# PREVOST

## IS-06900

### IMPROVING OVERHEAD COMPARTMENT AIR FLOW DISTRIBUTION

*Applicable for H3 series coaches equipped with WCL sliding door. Reference ECN2003050.*

FIGURE 1

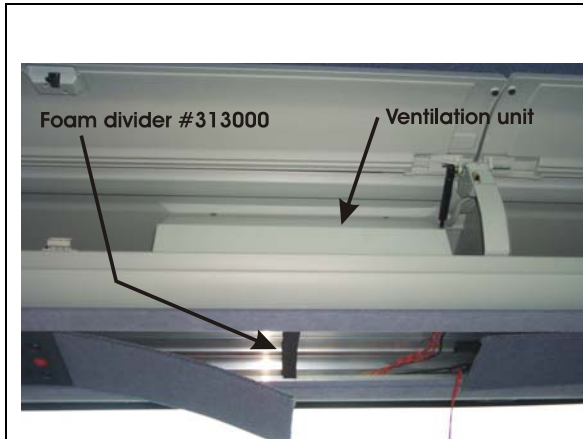
1. On vehicle R.H. side, locate the overhead hand luggage compartment containing the ventilation unit.
2. Remove the overhead console located under the ventilation unit (figure 1). Unplug the connector.
3. Install foam divider #313000 inside the ventilation duct at 317mm (12 ½ in) from the rear edge of the ventilation unit air outlet (figure 1 & 2).
4. Plug connector and reinstall the overhead console.
5. Open the overhead compartment located just before the WCL access door (figure 3).
6. Remove the gas spring. To do so, pry the metal strip with a small screwdriver (figure 4).
7. Remove panel shown on figure 3.
